AMENDMENT OF LICENSE
OPAL SPRINGS HYDROELECTRIC PROJECT
FERC PROJECT NUMBER 5891-000

REVISIONS TO EXHIBIT A

October 2015 (revised, October 2017)

Under separate cover, the DVWD is re-filing revised Exhibits A (Project Description), G (maps) and F (drawings) reflecting the changes necessary to bring these exhibits into conformance with the proposed amendment. For convenience, DVWD is also providing a “crosswalk” document that summarizes the changes from the 2015 proposal.

Attachment 7: Crosswalk of 2015 Proposed Action and 2017 Modifications

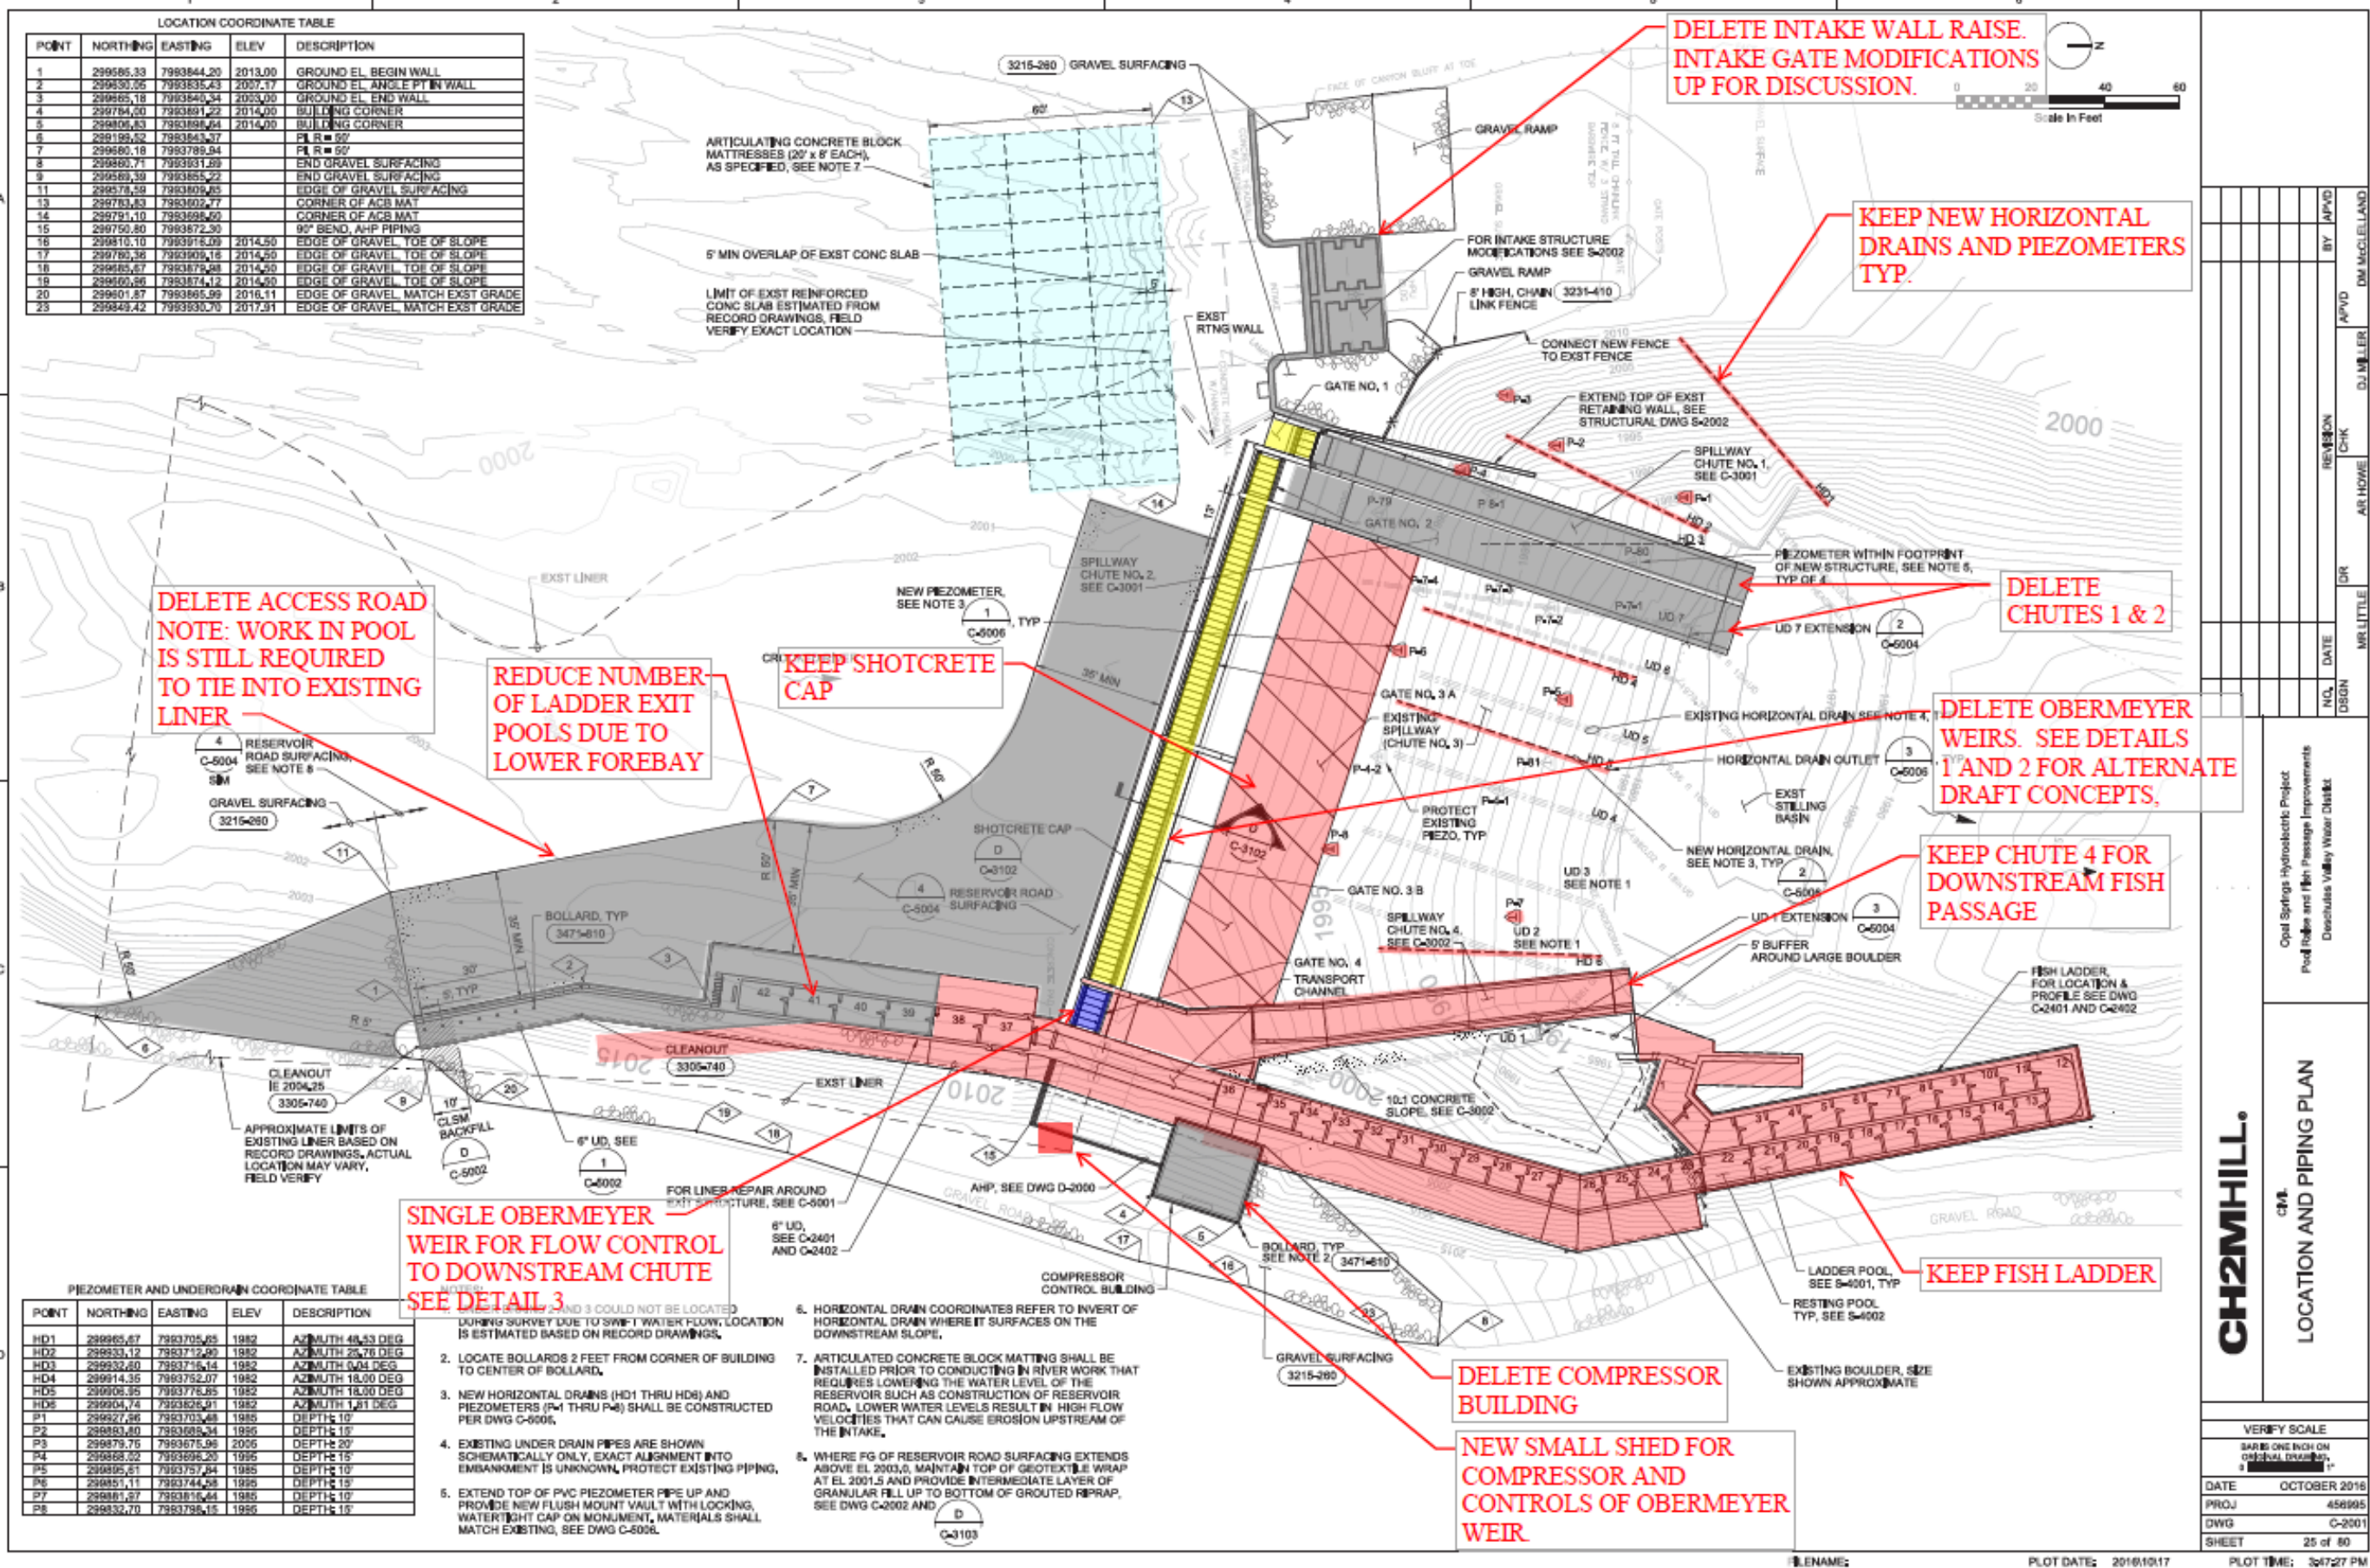
As noted in filings with FERC dated March 17, 2017, the Opal Springs Hydroelectric Project (OSHP) underwent value-engineering efforts regarding the proposed fish ladder and pool raise after it was determined that the lowest bid for construction was not economically feasible. The result of the value-engineering was a slight modification to the project description in which some of the project elements were removed entirely while others were modified to maintain the economic viability of the project (Figure 1). The crosswalk below describes the changes seen in Figure 1.

2. Figure 1 is a marked-up layout of the original drawings from the 2015 application. Changes to the project layout are reflected here.
3. Attachment A is a track changes of the proposed Exhibit A for the project.
